Office Action Summary

10/799,534

YU ET AL.

DETAILED ACTION

In figure 2A, the inflow tube is depicted as portion B and the adapter is depicted as portion A, as indicated accordingly.

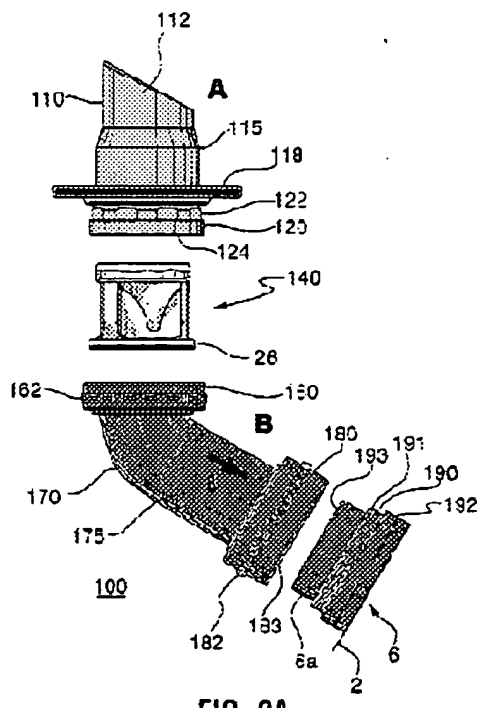
1. Claims 1-5 and 7-13 are rejected under 35 U.S.C. 102(e) as being anticipated by Mussivand et al. (US 6,290,639). Mussivand et al. discloses a conduit assembly in figure 1 and 2A. As seen in figure 1, the system includes a VAD 2 as a pump portion, an inflow tube protruding from the pump and an adapter sleeve. The inflow tube and

adapter sleeve can be seen more clearly in the replication of figure 2A below.

As to claims 9, 11 and 13, since the inflow tube also includes the inflow port extension 6a, the examiner considers the inflow tube to be

extendable. Furthermore, this inflow port extension 6a is also an inner sleeve that extends inside the inflow tube.

As to claims 2-3 and 7, the adapter also includes a sewing ring or skirt 118 to suture to the ventricular apex. Furthermore, the examiner also considers the sewing ring or skirt 118 to be a gripping member for attaching the inflow tube to the ventricular apex.

As to claim 8, the elbow assembly 170 is the bent end of the inflow tube as seen in figure 2A.
